February 2nd, 2017
Peru State College, Theatre and Event Center Renovation and Addition
Peru, Nebraska

ADDENDUM #2

4 CURTAIN WALL INTERIOR SOFFIT
A3.1 1" = 1'-0"

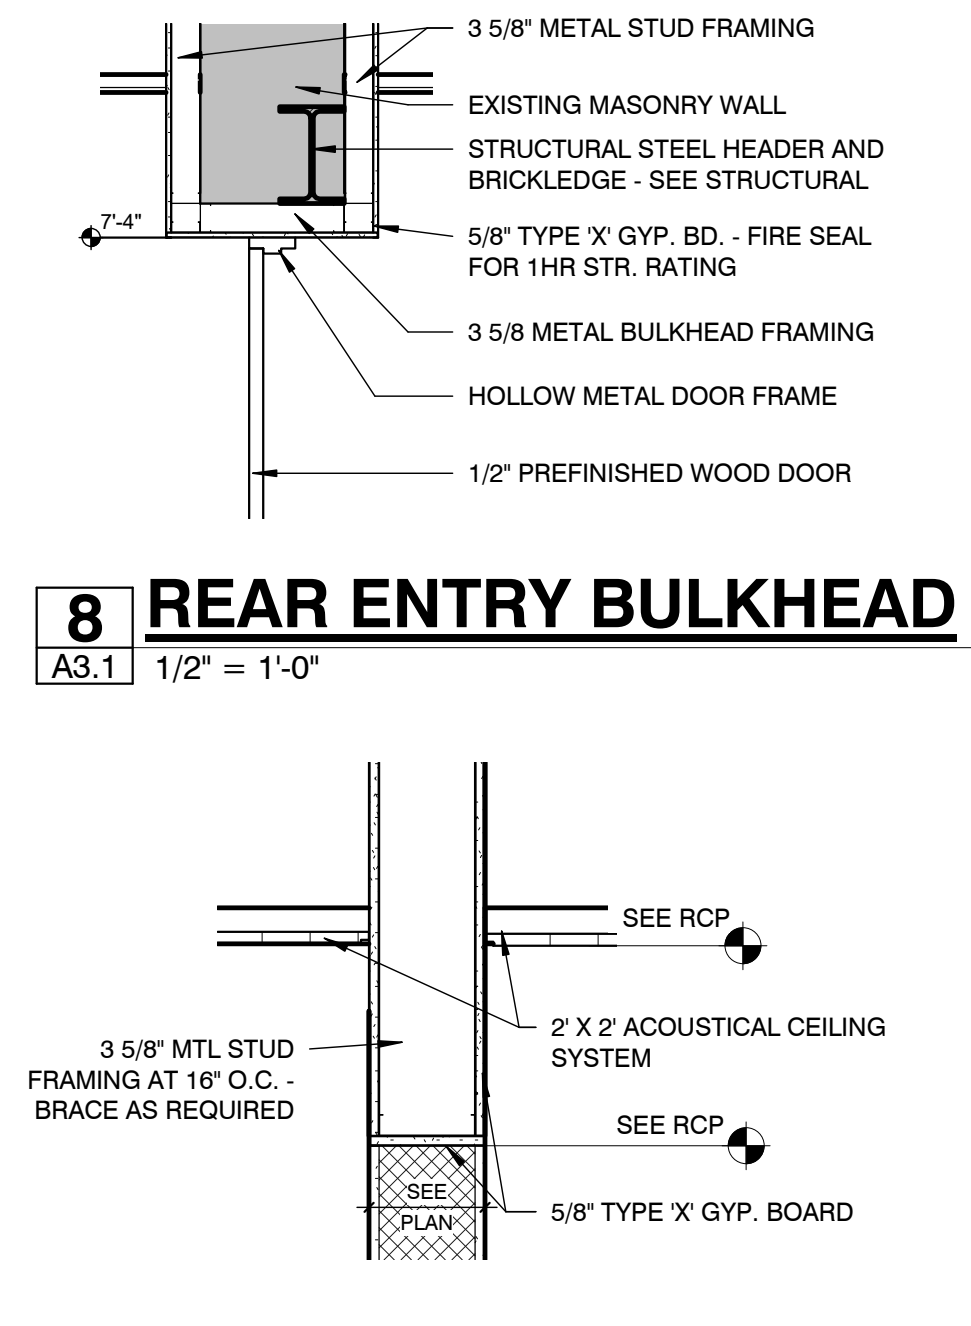
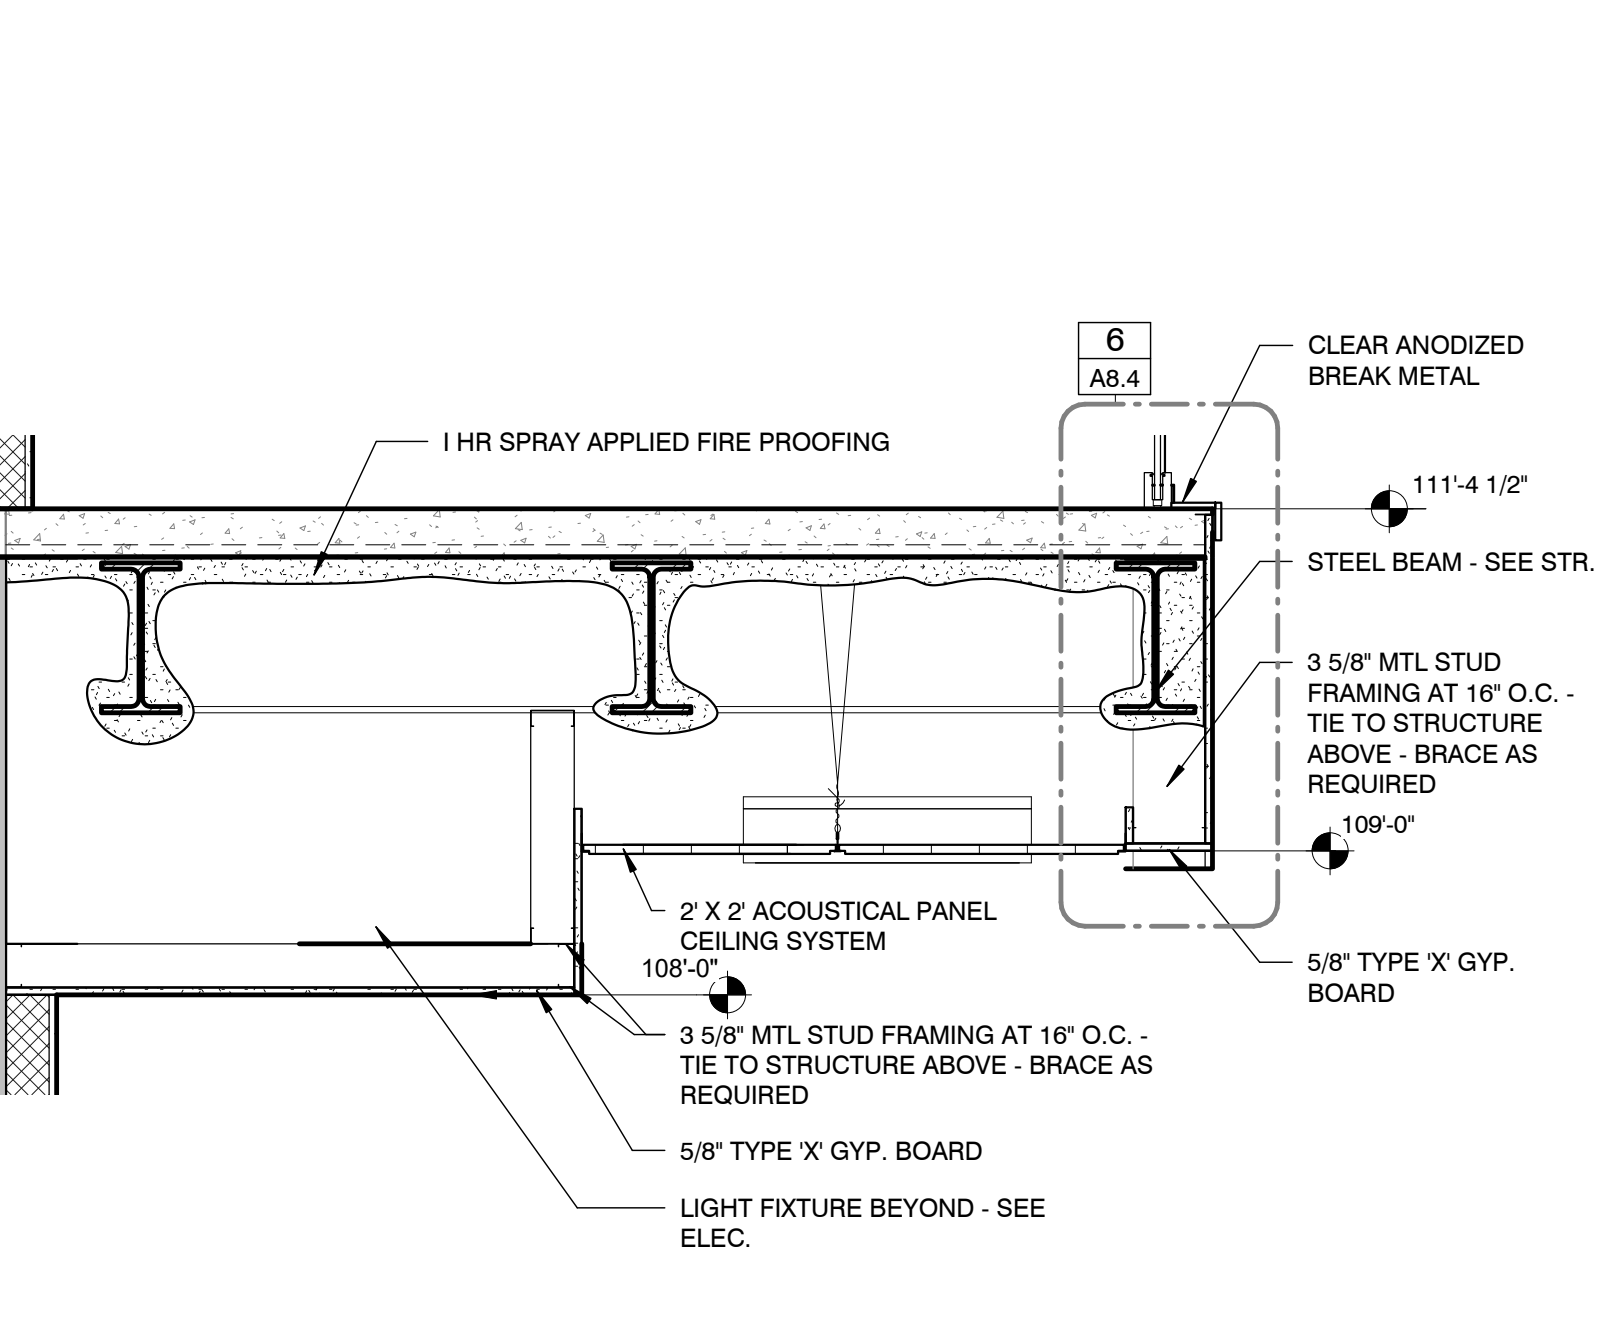
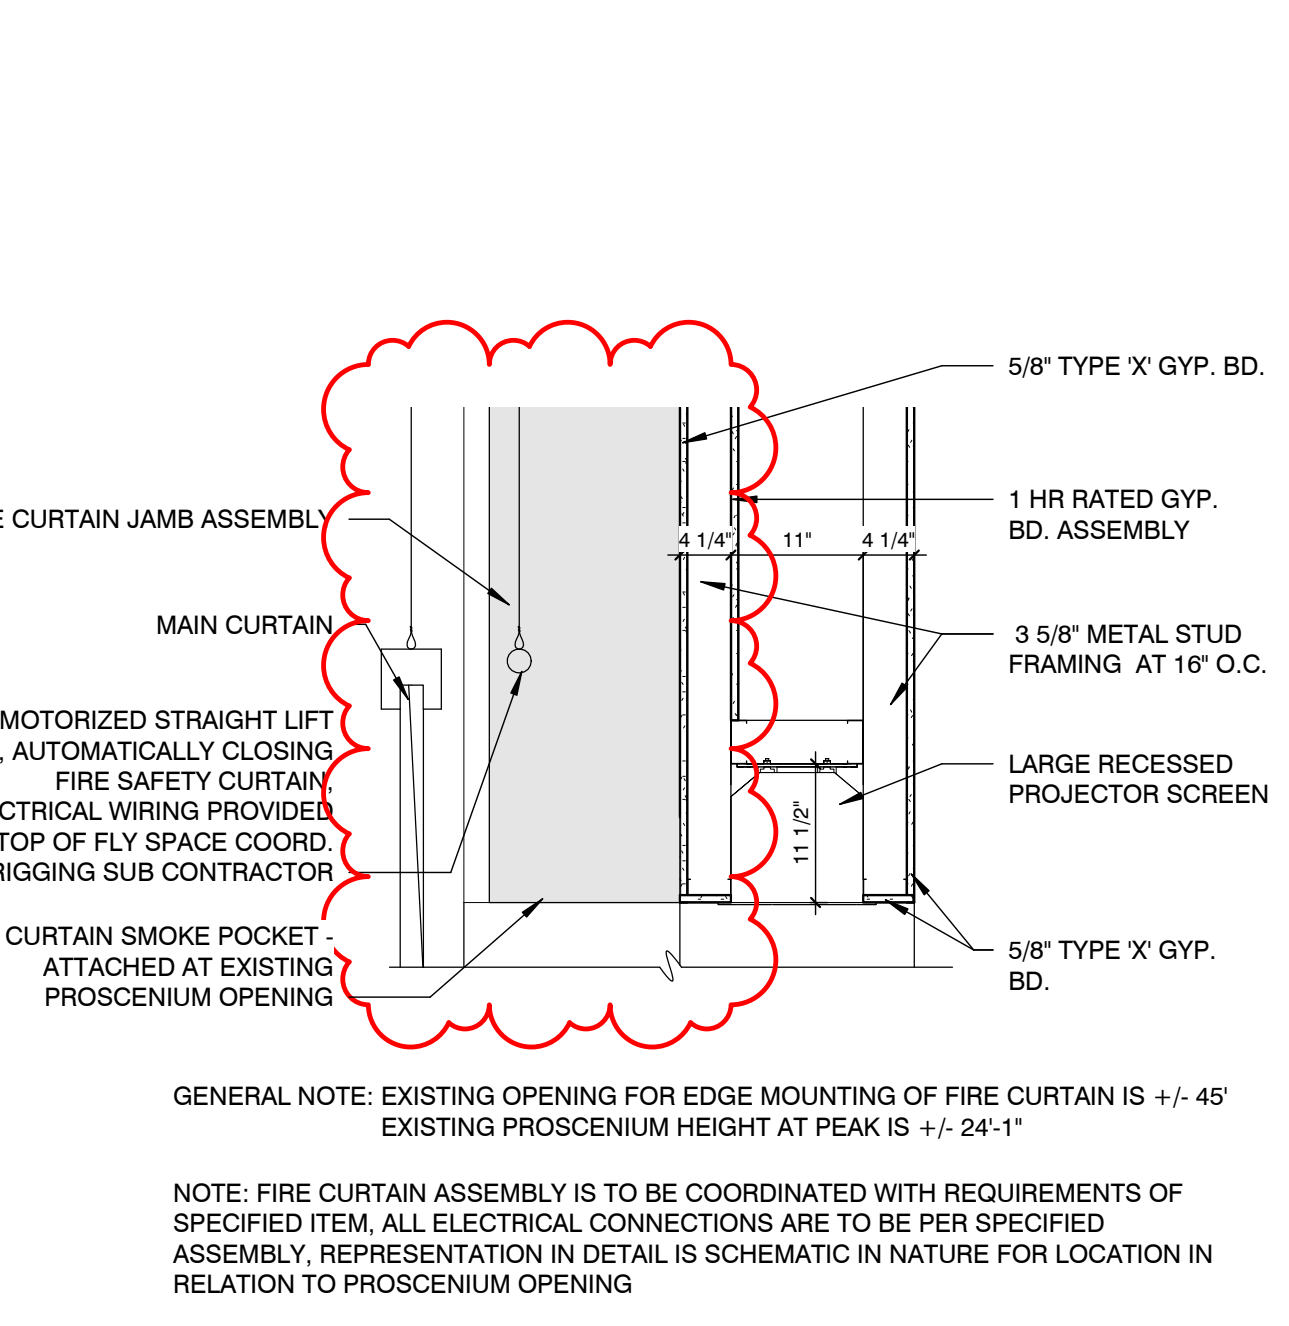
- A. See attached revised sheet A3.1

There's a conflict between 1161 00.203.A.1 ("motorized straight lift type, automatically closing fire safety curtain") and drawing.

The Curtain assembly shown 7/A3.1 is inaccurate, the specified fire curtain assembly will need electrical to be routed to the top of rigging grid.
